Live Oak Park (aka: Scout House)

Construction Impact Report (Moreton Bay Fig)

APRIL 13, 2022

Site map 3, Provided by the client.

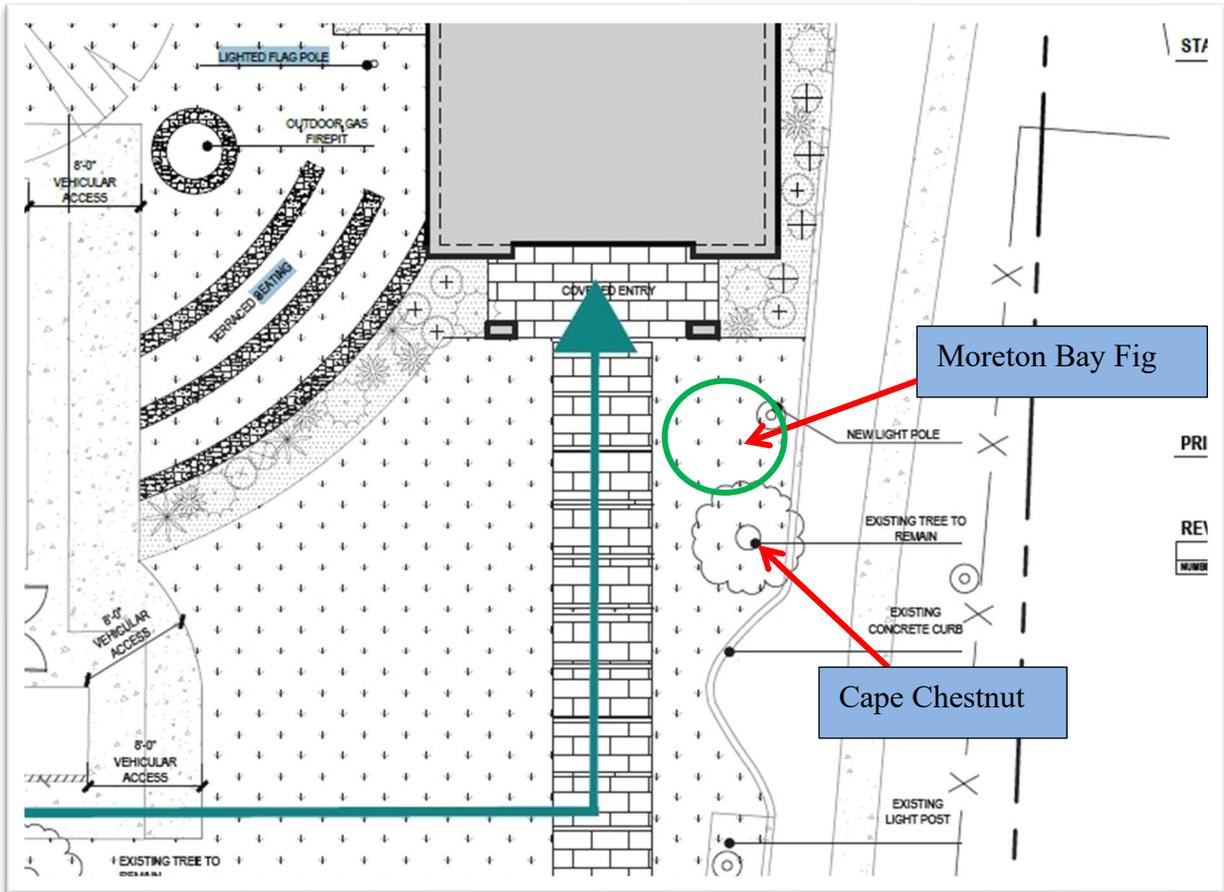
Note that in this image, only one tree is shown as “existing tree to remain.” Comparing street views, Google maps, and on-site observations, there are two trees very close to each other, the subject fig tree and a smaller Cape Chestnut. This site plan actually shows the smaller of the two, as it is the one nearest the bowed curb. See Image 5.

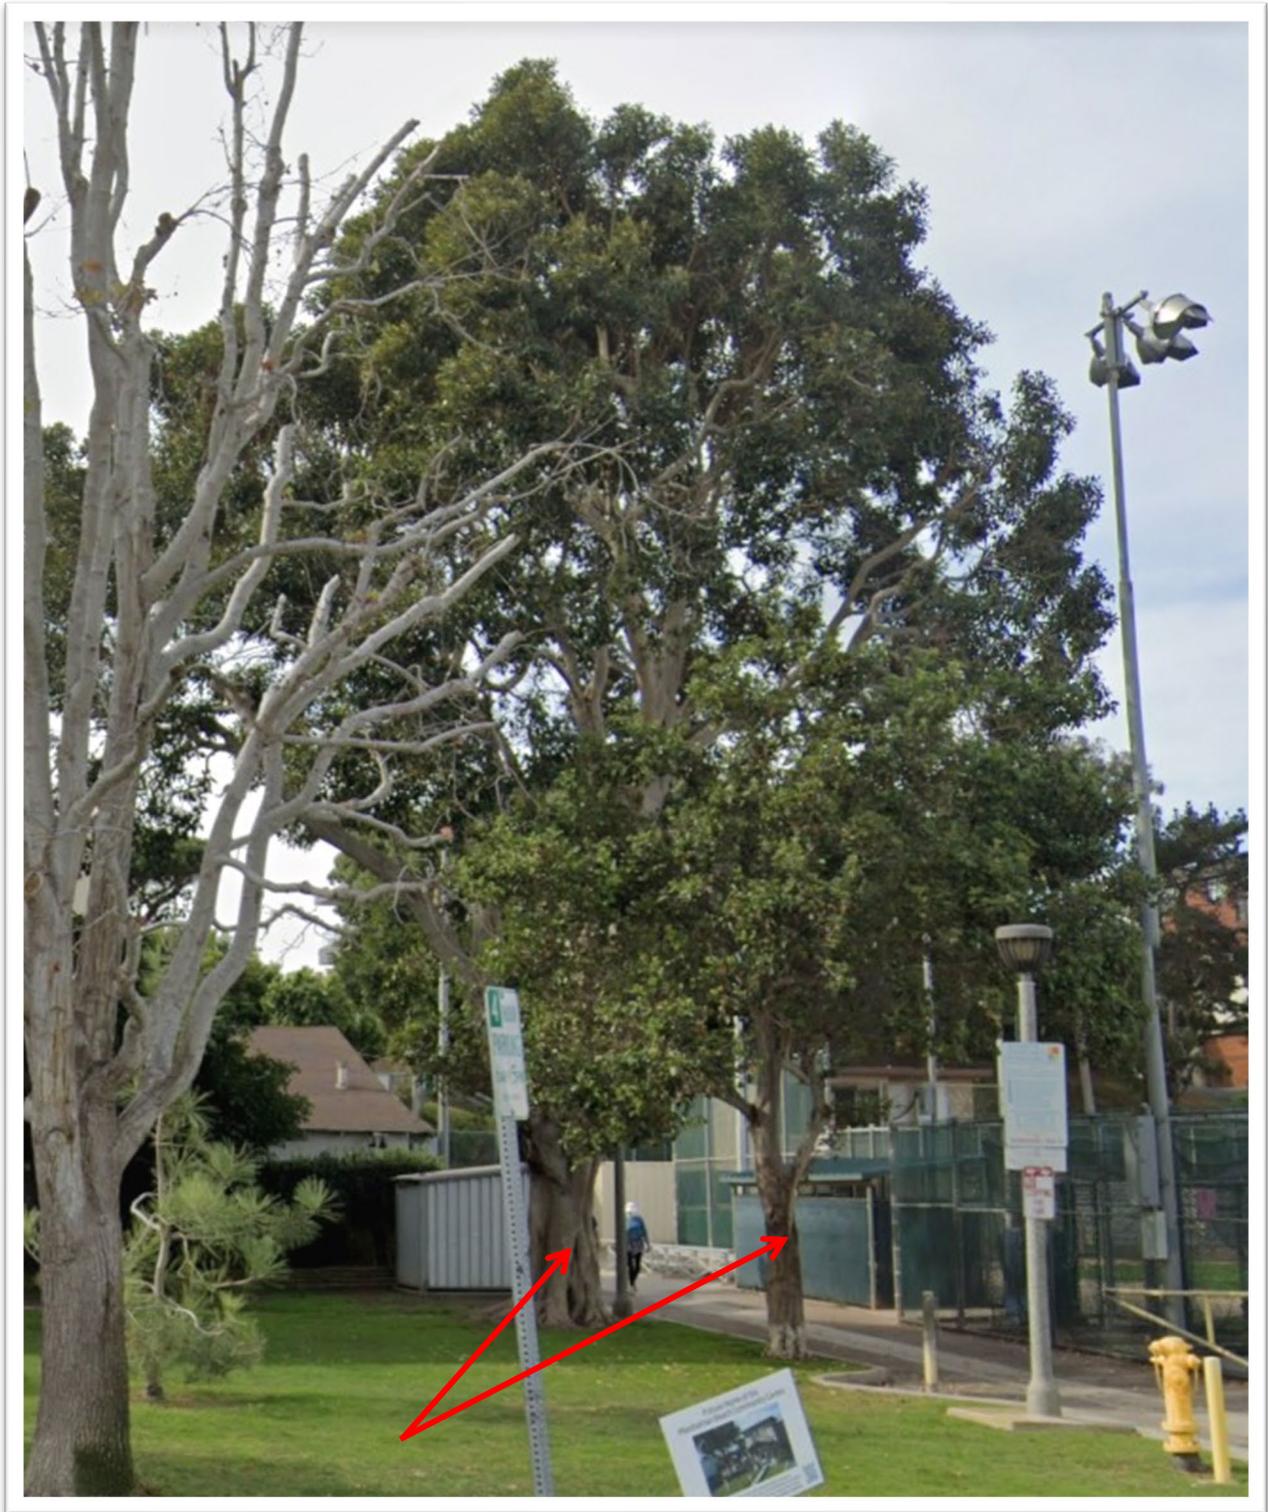
Image 4. Showing the root flare and how it spreads out significantly from the tree base. Plans call for a new light standard to be installed in the area indicated, this will act to sever all the support roots on the west side. In addition, a covered entrance way is planned that would require the removal of the large lateral. This would result in uneven weight distribution. When combined with the expected root loss, this action could result in a loss of plant stability.
